DETAILS OF Columns & Beams	
PROJECT	SpiceWood Springs Conversion
LOCATION	
CUSTOMER	
ARCHITECT	Architects
ENGINEER	Engineering

DETAILS OF Columns & Beams			
PROJECT <u>SpiceWood Springs Conversion</u>			
LOCATION _____			
CUSTOMER _____			
ARCHITECT <u>Architects</u>			
ENGINEER <u>Engineering</u>			
DETAIL <u>DY</u>	DATE <u>5-12-08</u>	REV # <u>0</u>	SHEET # <u>D1</u>
CHK.R _____	SHOP CODE _____

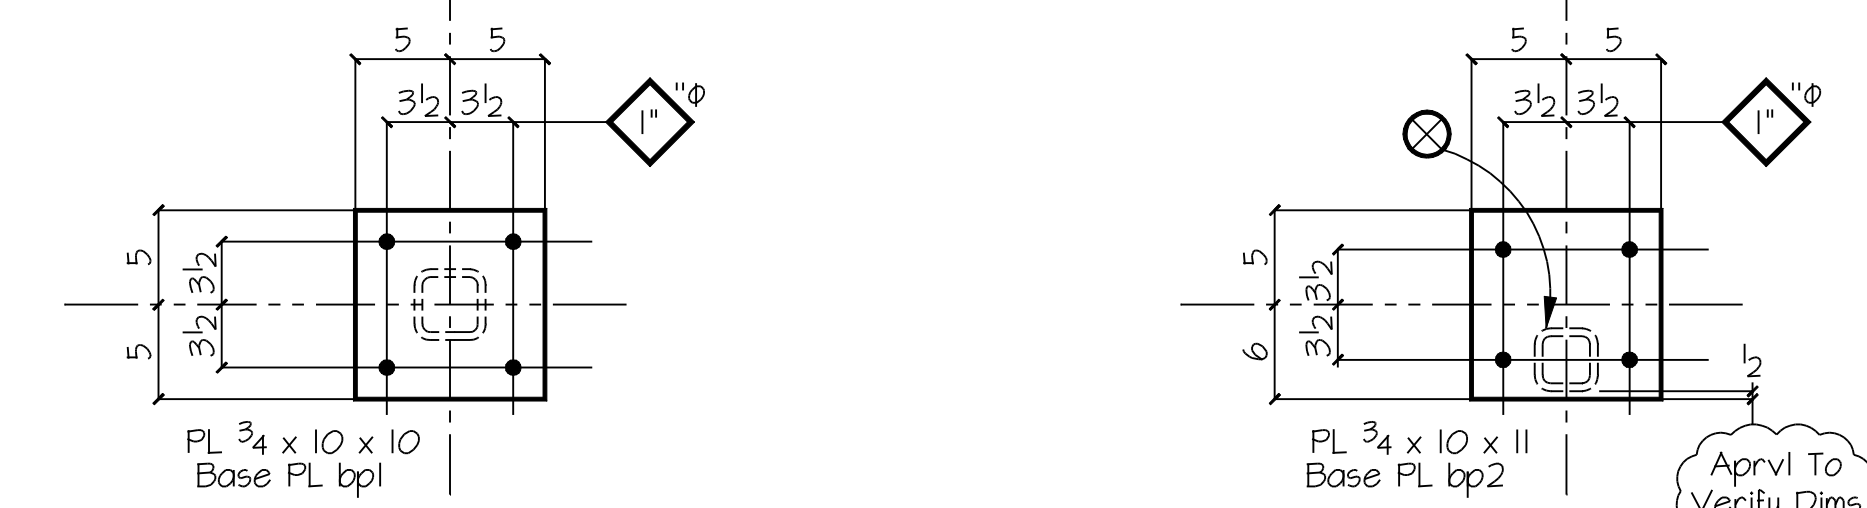
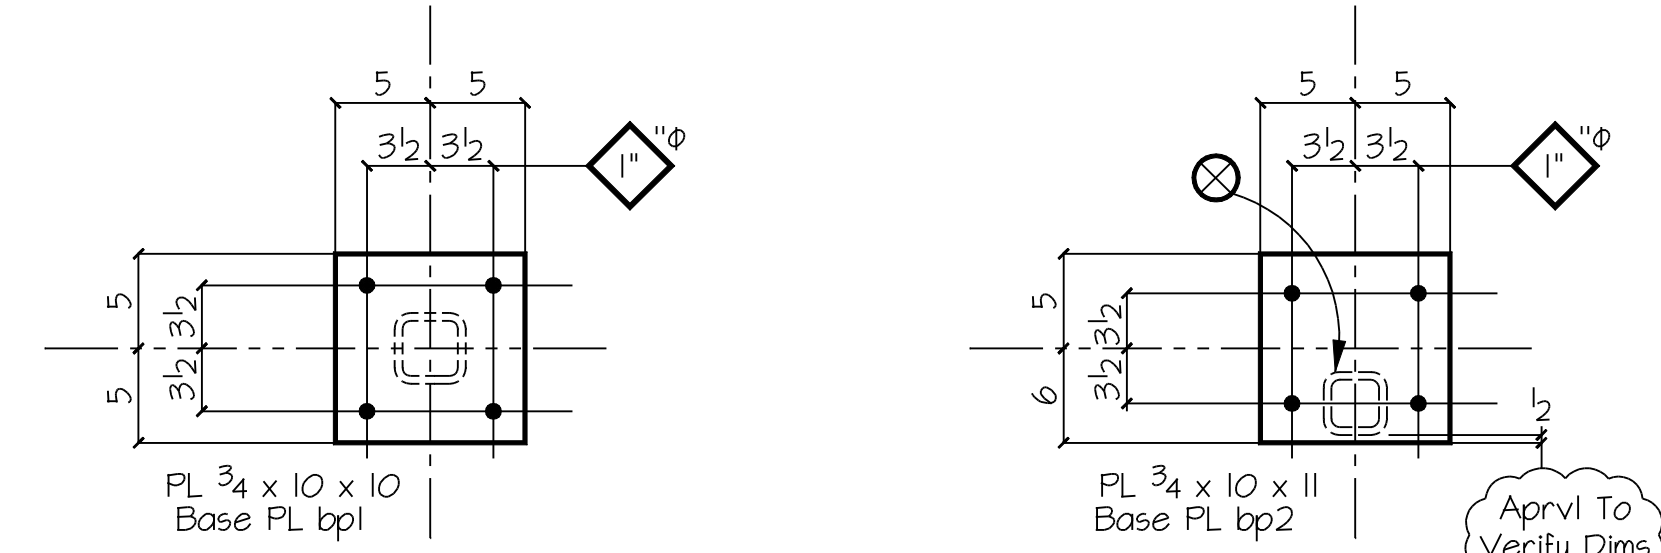
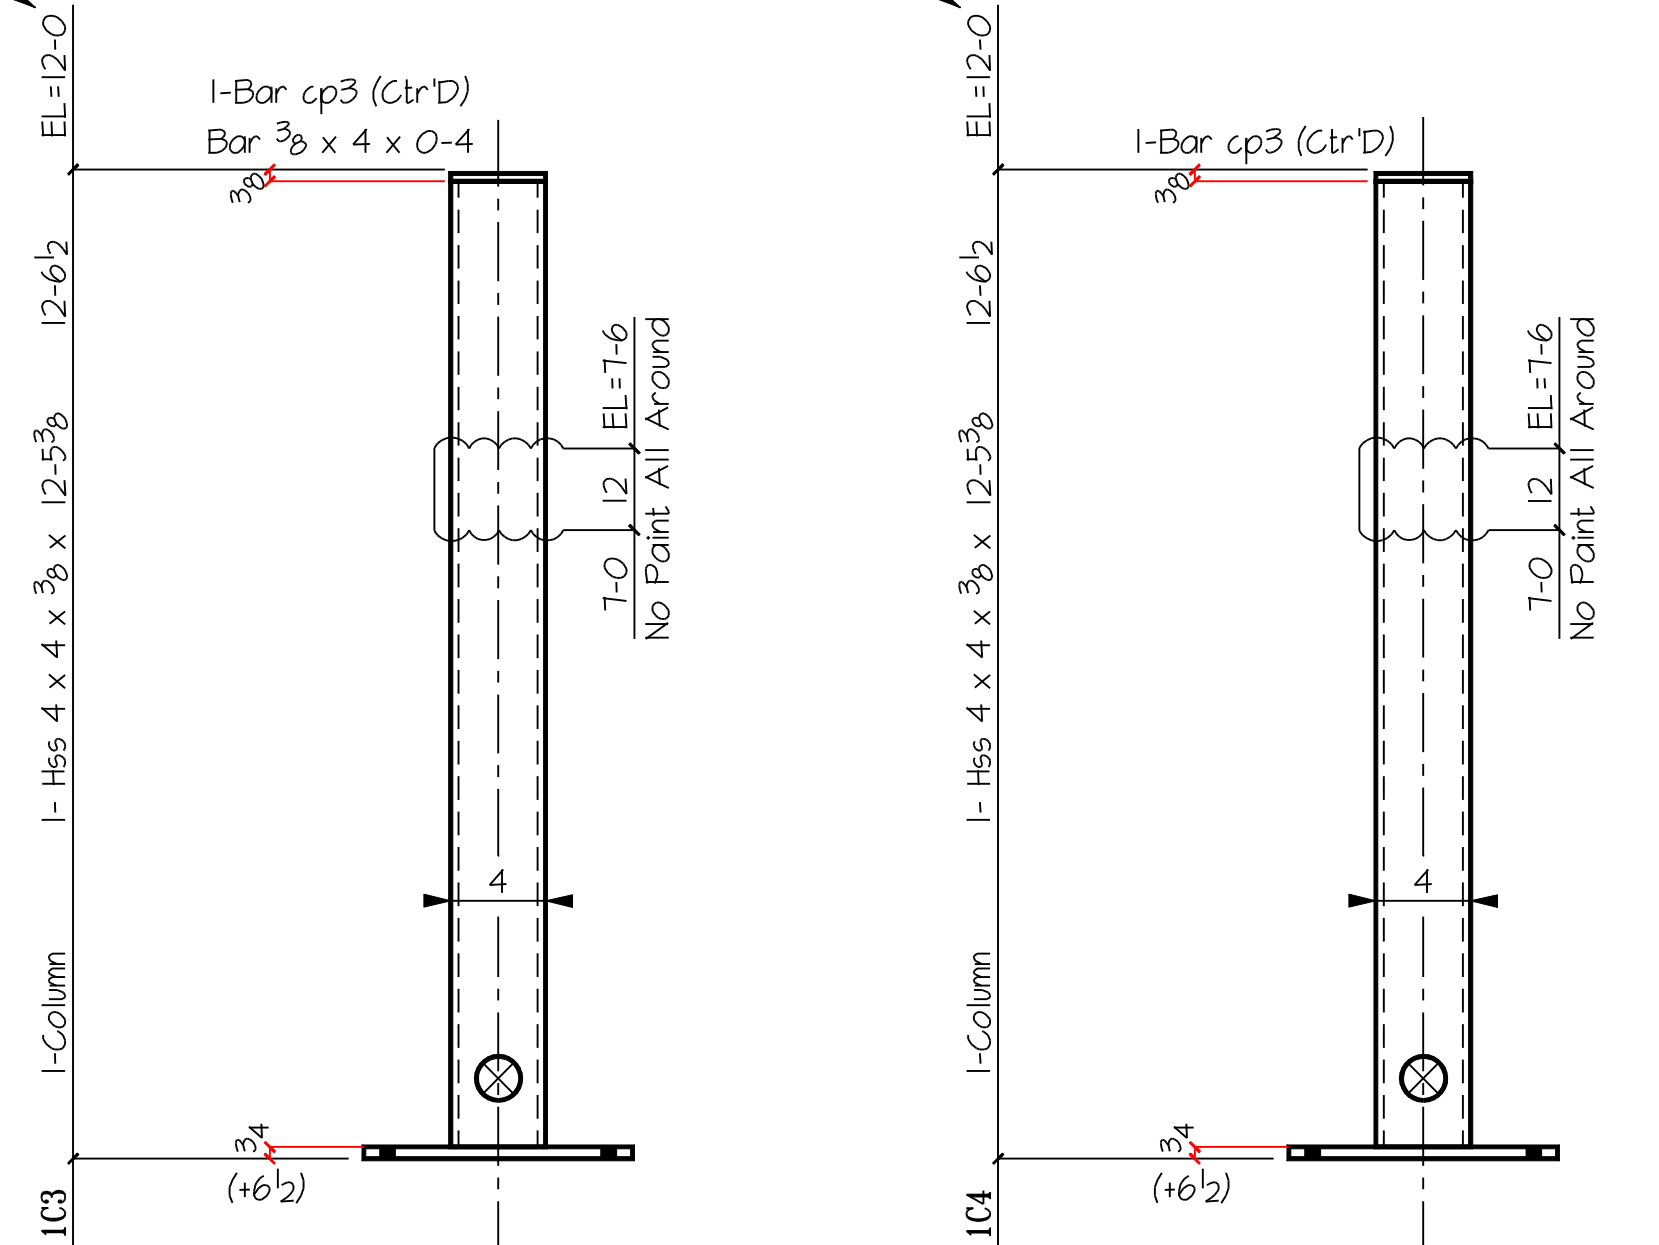
Approval To Verify Elevation

Approval To Verify Elevation

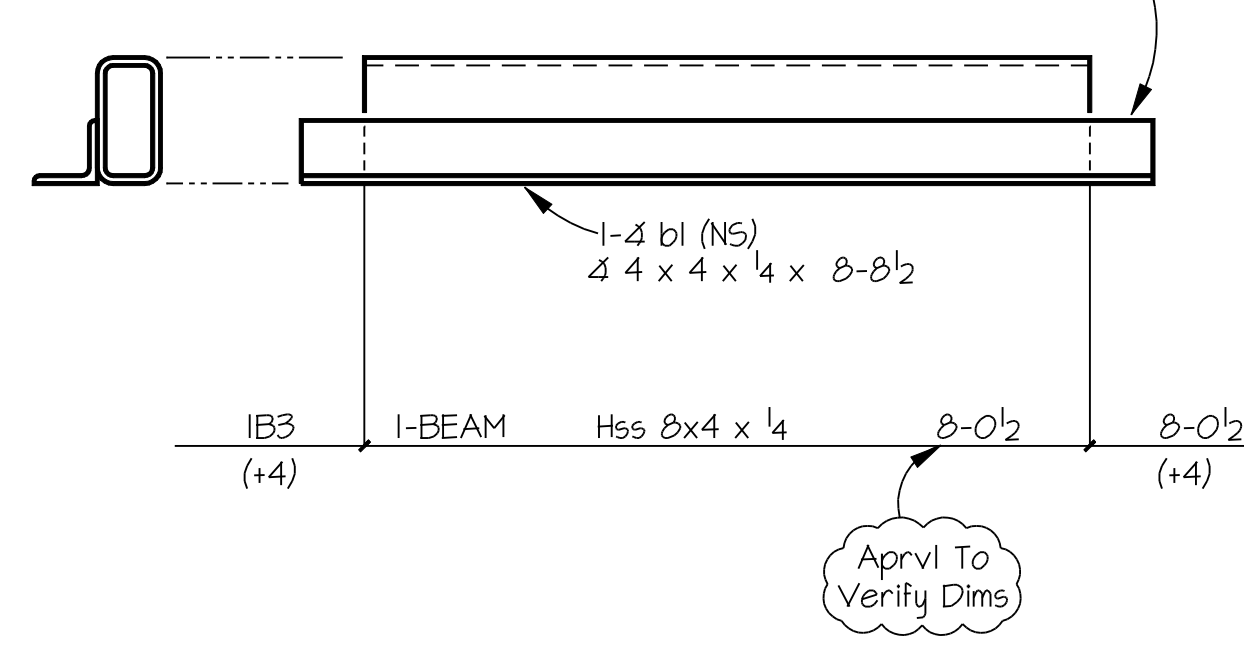
Approval To Verify If 4" Overhang is Req'd
